Project No. 2021\_154

MIDLOTHIAN ISD STADIUM ADDITIONS AND RENOVATIONS

ADDENDUM NO. 2

DATE: October 18, 2021

SHEET CONTENTS  
PRESSBOX FLOOR  
PLAN

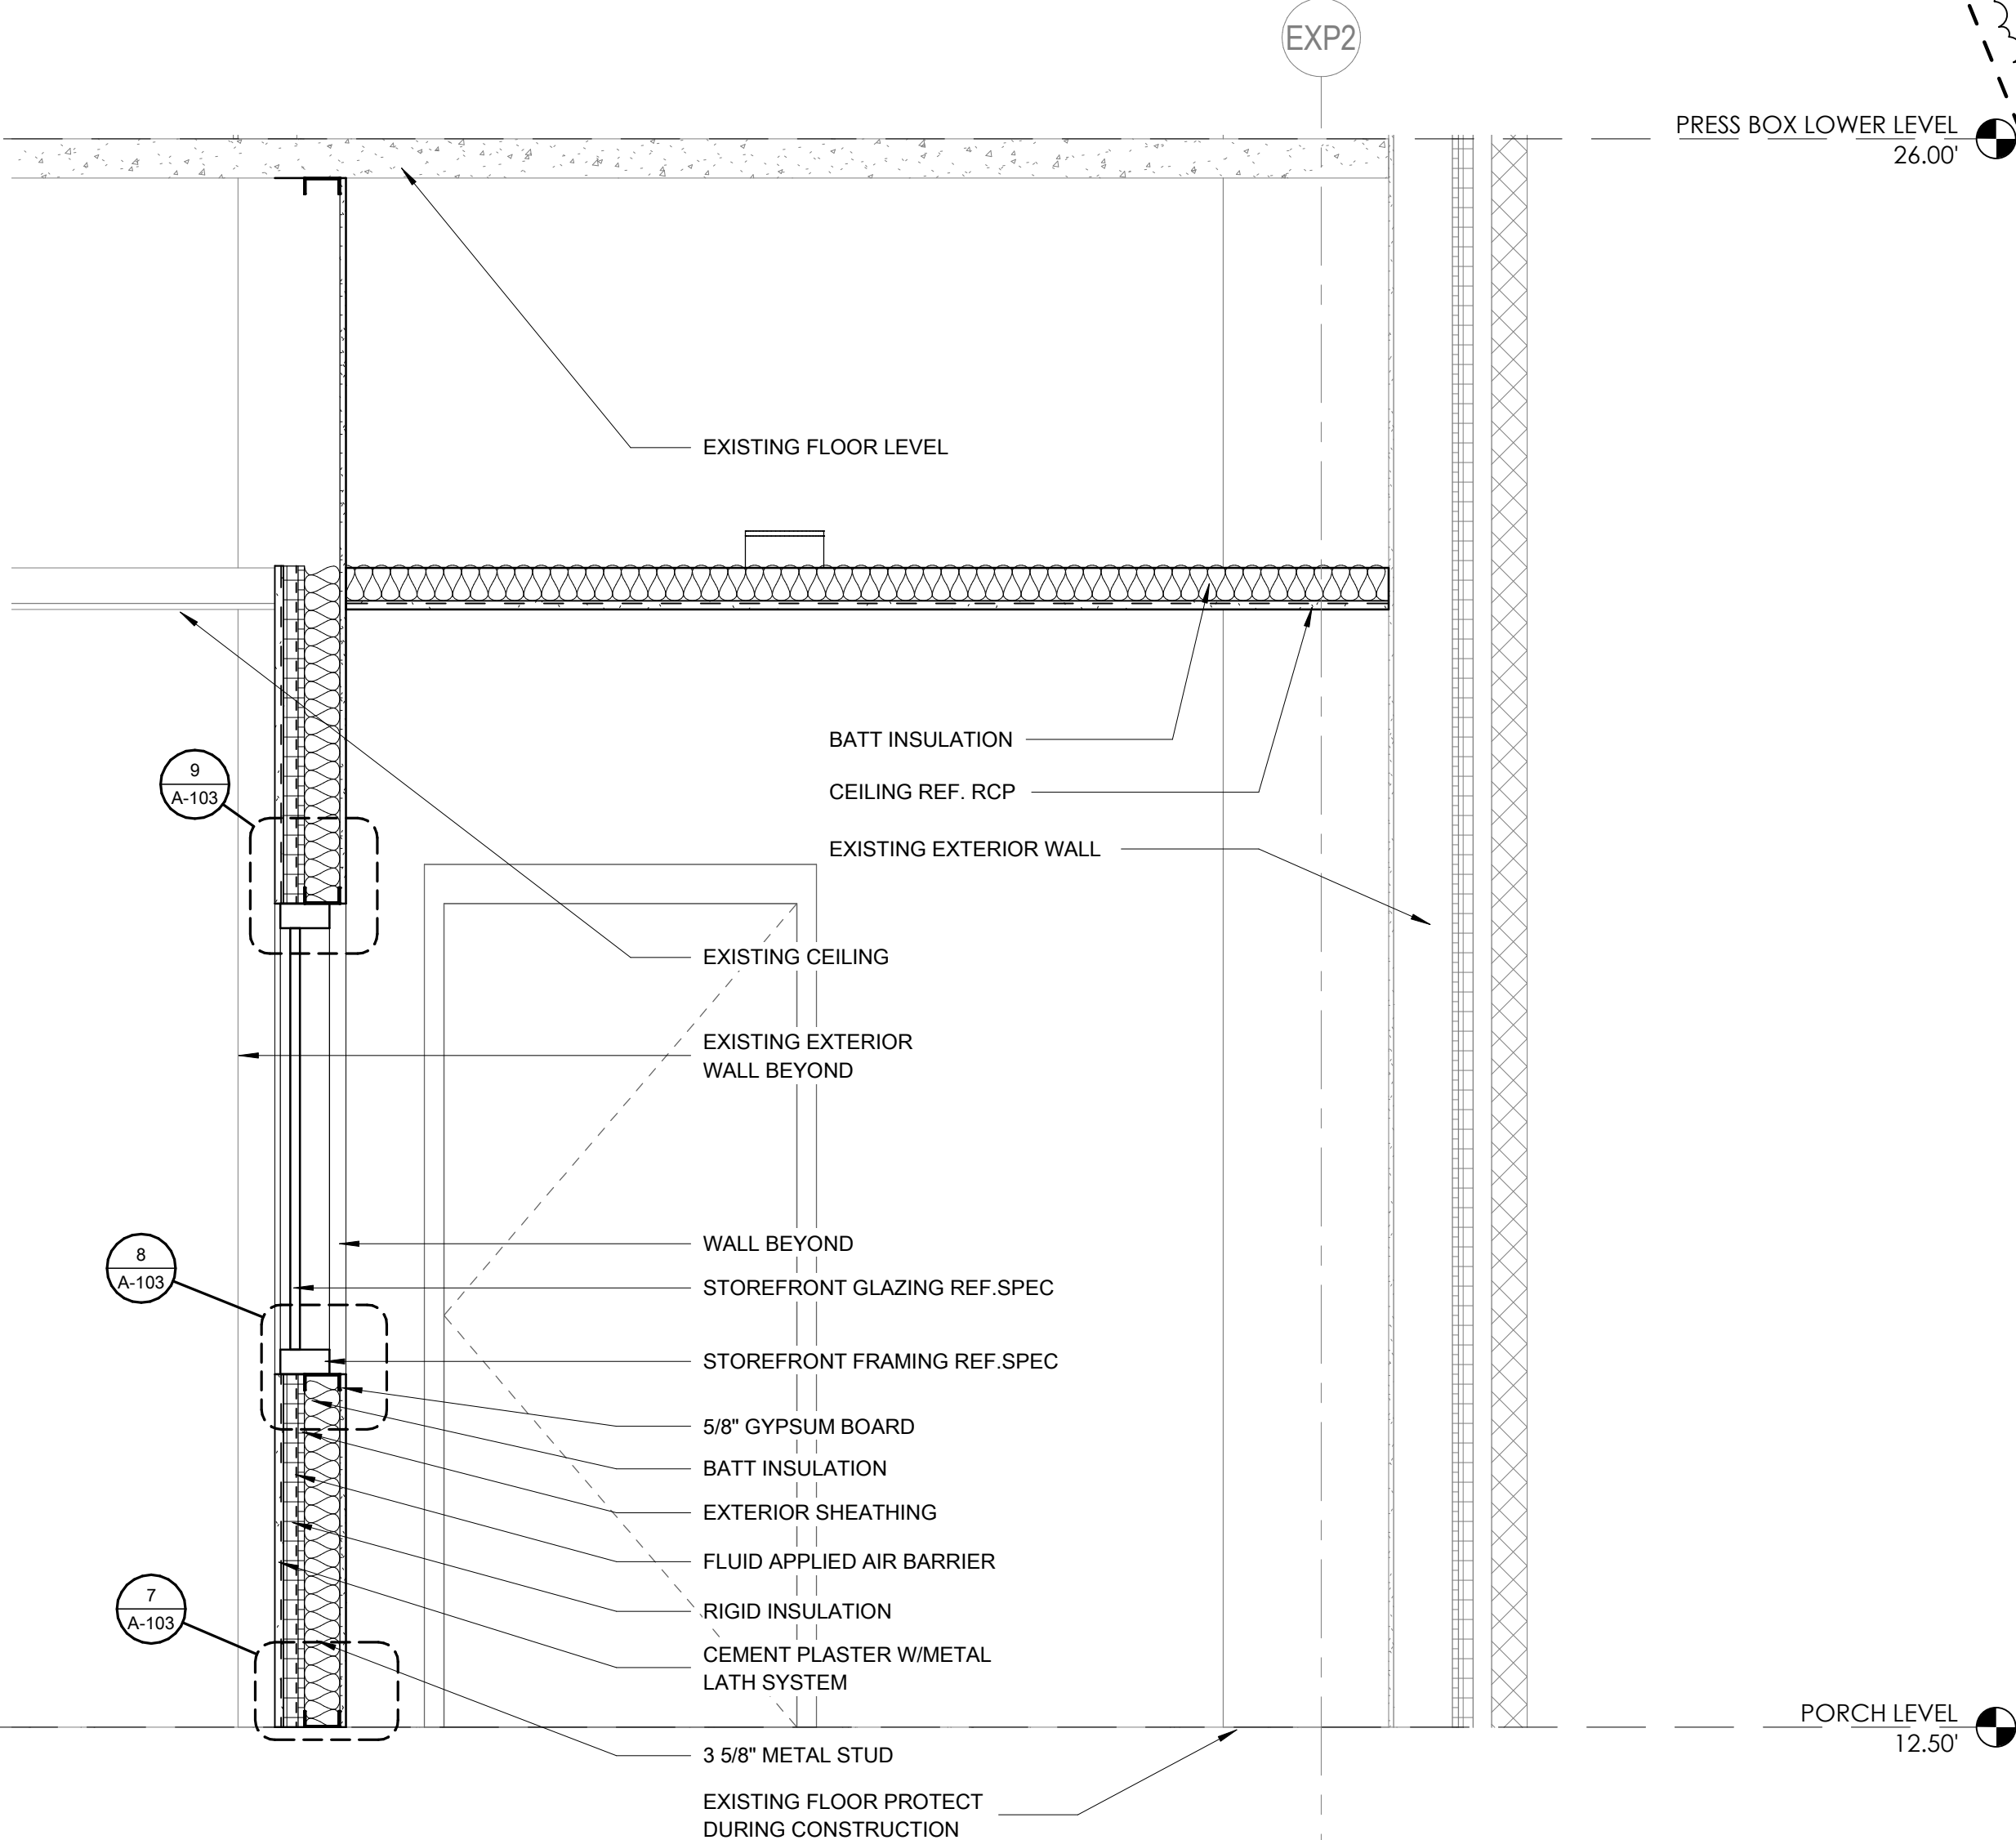
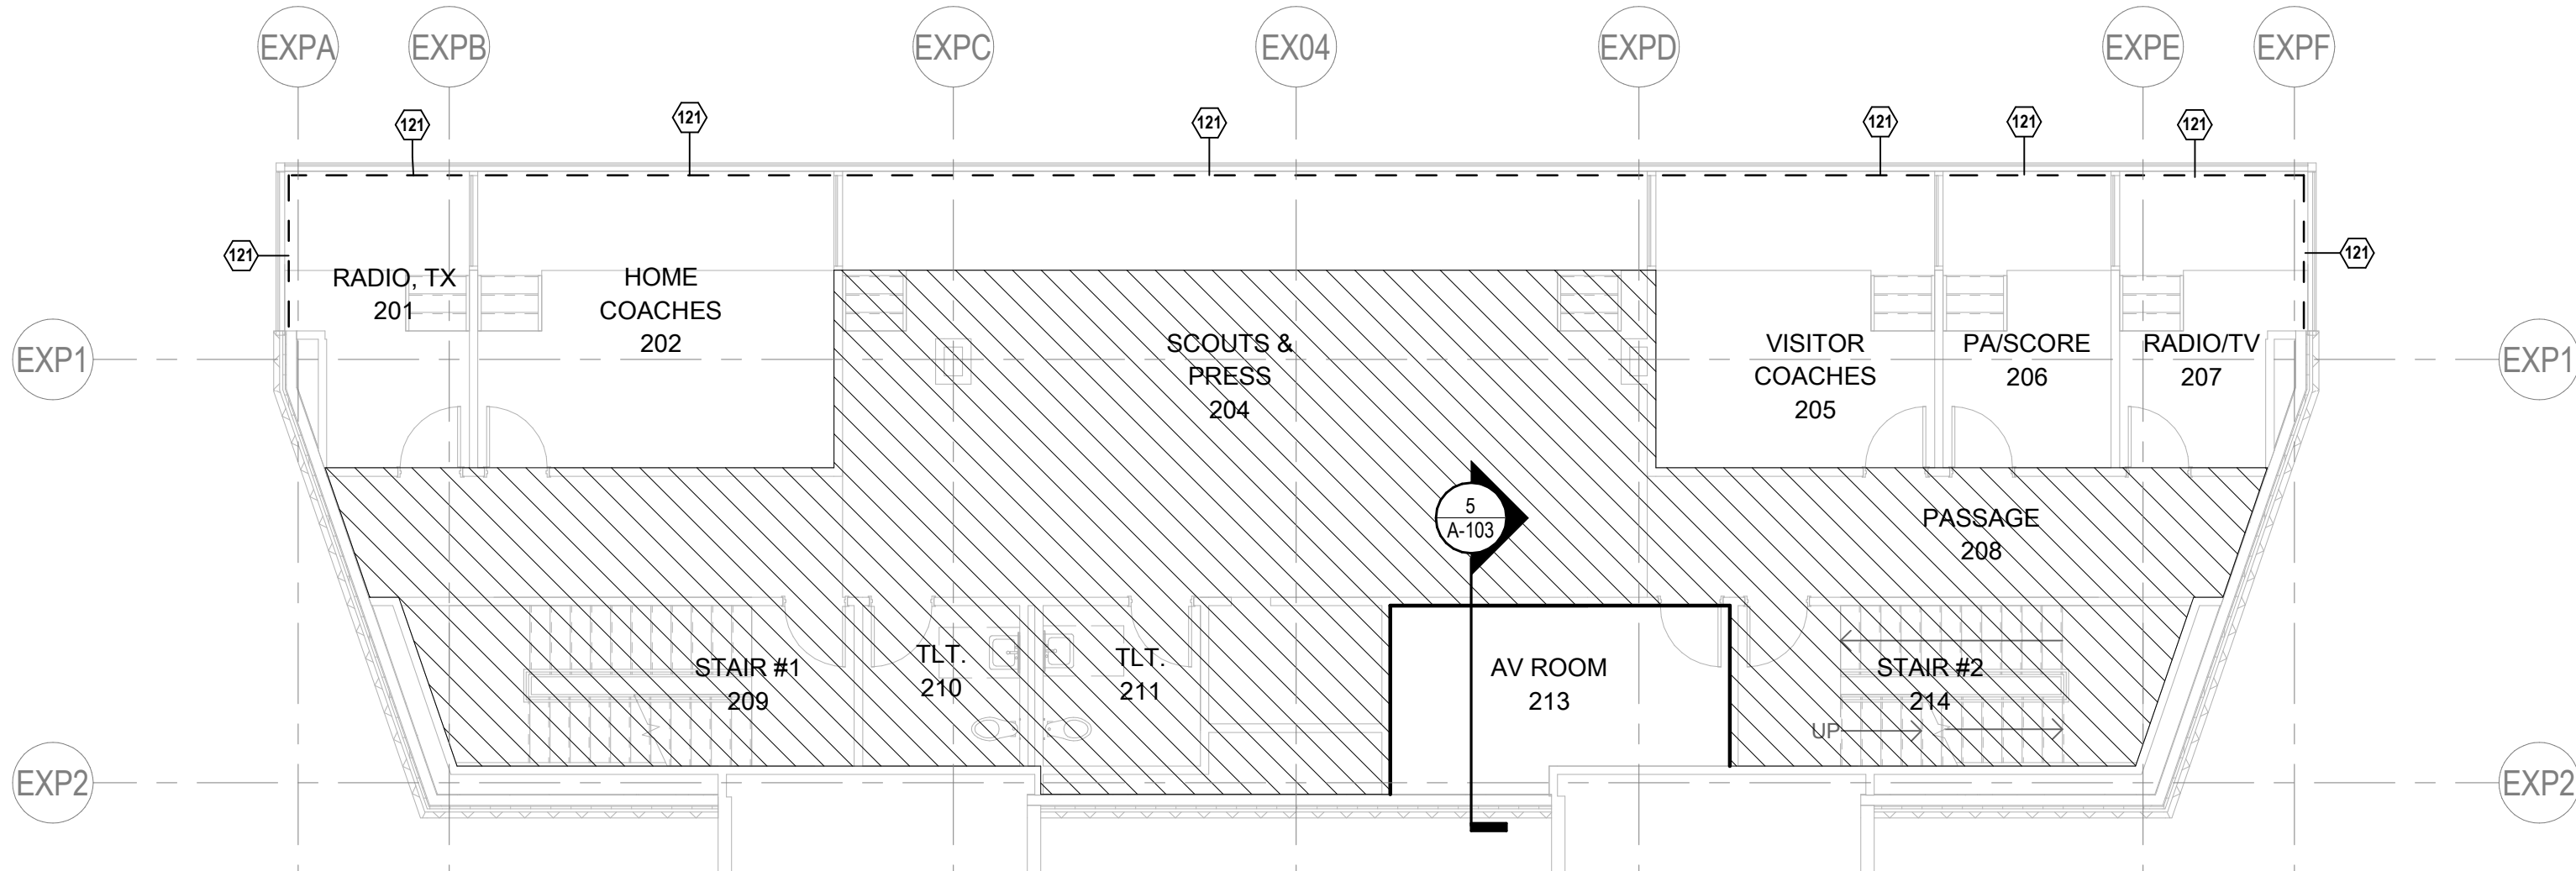
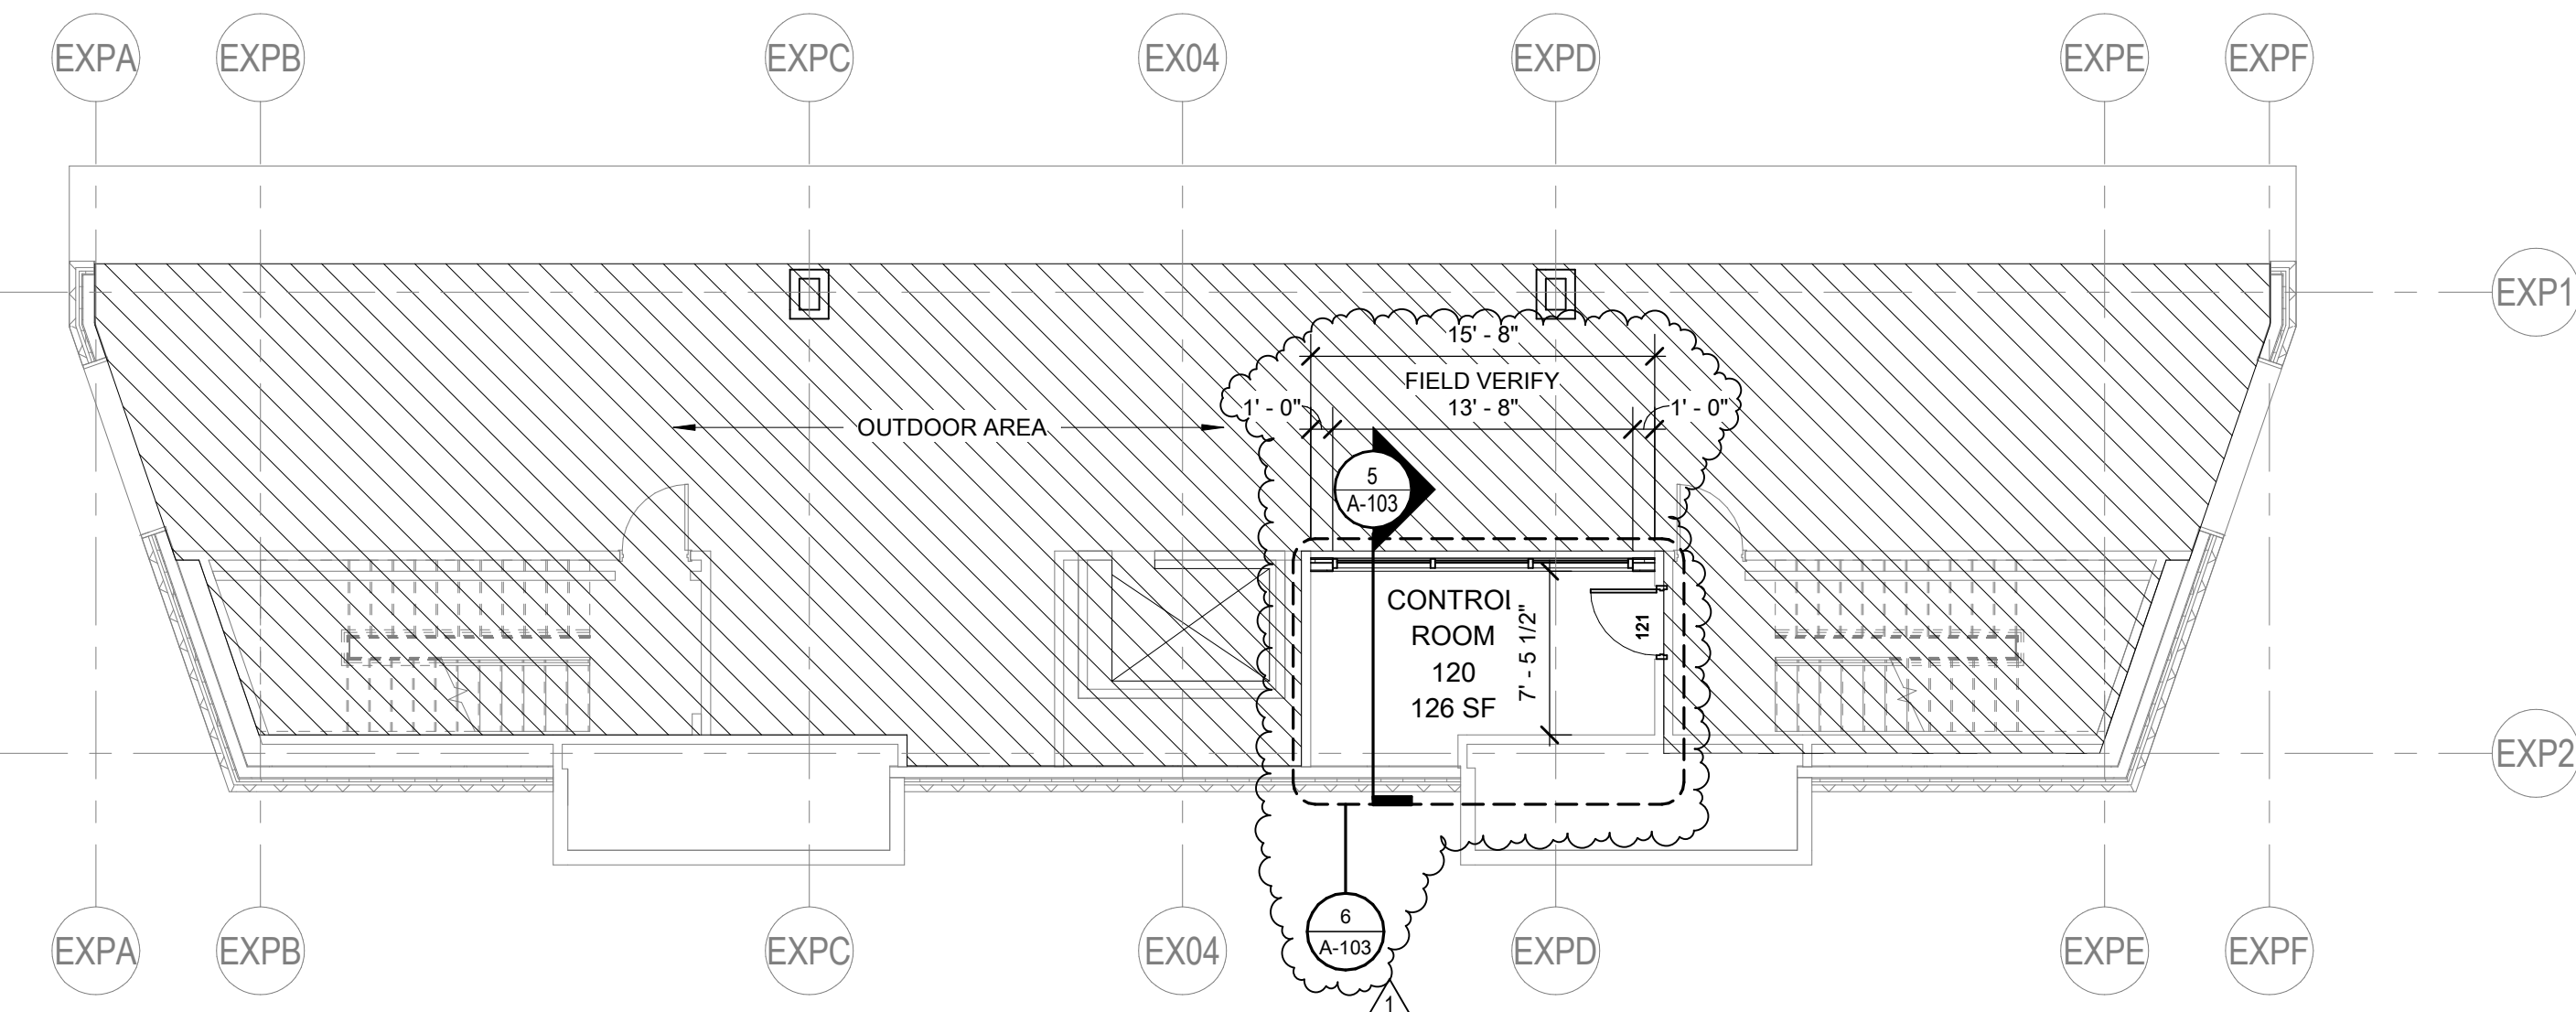
- A2.10 SHEET A-103 – PRESSBOX FLOOR PLAN:  
REMOVE and REPLACE in its entirety.  
a. Control Room 120 MOVED entirely to the other side of existing elevator. Door 121 will be installed in existing fire rated stair well.

b. DEMOLISH existing CMU wall area 3'-0" X 7'-4" to install new door.
- A2.11 SHEET A-113 – PRESSBOX RCP:  
REMOVE and REPLACE in its entirety.  
a. Control Room 120 ceiling MOVED entirely to the other side of existing elevator.
